**SAFETY EVALUATION BY  
THE OFFICE OF NUCLEAR REACTOR REGULATION  
RELATED TO NRC GENERIC LETTER 2004-02,  
NUCLEAR ENERGY INSTITUTE  
GUIDANCE REPORT  
(PROPOSED DOCUMENT NUMBER NEI 04-07),  
“PRESSURIZED WATER REACTOR  
SUMP PERFORMANCE EVALUATION METHODOLOGY”**

The Nuclear Energy Institute (NEI) submitted its report, "Pressurized Water Reactor Sump Performance Evaluation Methodology," (proposed document number NEI 04-07) in May 2004 to the U.S. Nuclear Regulatory Commission (NRC or the staff) for review (NEI, 2004a). The objective of this safety evaluation (SE) is to document the staff's review of methodology guidance for licensees of pressurized water reactors (PWRs). This SE relates to NRC Generic Letter (GL) 2004-02, "Potential Impact of Debris Blockage on Emergency Recirculation During Design Basis Accidents at Pressurized-Water Reactors," issued September 13, 2004 (GL-04-02).

**Figure 3-1. Comparison of GR Isobar Map (Blue) with Isobars from Independently Evaluated ANSI Jet Model (Red)**

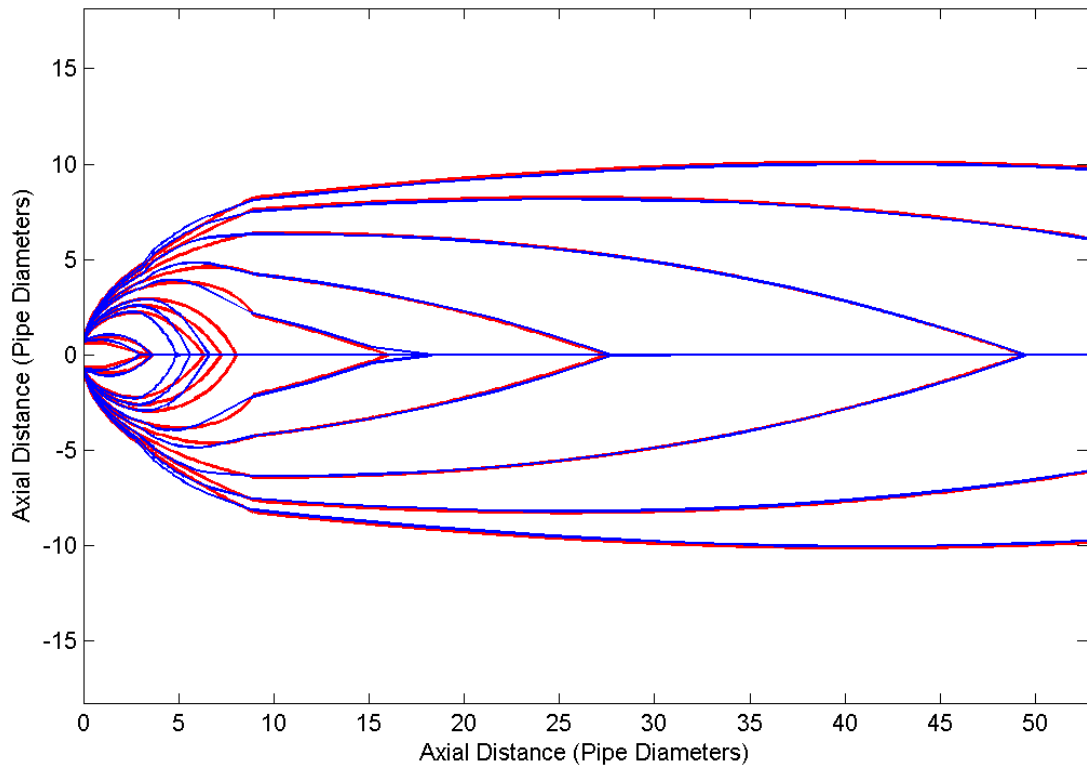
In order to confirm that the ANSI jet model was implemented properly, the model was independently programmed and the results compared with the isobar map tabulated in Table D-1 of the GR. This comparison is shown in Figure 3-1 in which the blue contour lines represent the GR evaluation of a break at 2250 psia and 540°F and the red contour lines represent a reference cold-leg break at 2250 psia and 530°F. Appendix I to this SE provides further explanation of the independent calculation and additional guidance on interpreting the results of the ANSI jet model.
